ECE/TRANS/WP.29/GRE/2009/64 16 July 2009

REGULATION No. 48 (Installation of lighting and light-signalling devices)

Clarifications on installation requirements

Proposal for draft Supplement 5 to the 04 series of amendments to Regulation No. 48

Figure 1b: Front (trailers only)

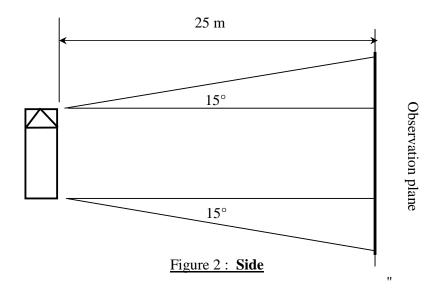
"6.21.5.1. for rear **and front** conspicuity markings (see Annex 11, Figures 1**a and 1b**) the observation plane is perpendicular to the longitudinal axis of the vehicle situated 25 m from the extreme end of the vehicle and bounded by:"

Annex 11, amend to read:

"Annex 11
VISIBILITY OF CONSPICUITY MARKINGS TO THE REAR, FRONT AND SIDE OF A VEHICLE

This document aims to introduce provisions in Regulation No. 48 to allow the installation of line markings on the front of large trailers (vehicles of categories O_2 , O_3 and O_4).

Although the front of trailers is normally not directly visible when used on the road, since it is more or less concealed by the vehicle that is towing it, there are situations in which the trailer's height exceeds that of its towing vehicle. Therefore, it is proposed to only allow a line marking to the front of the trailer, because the marking actually only needs to be visible when parked.
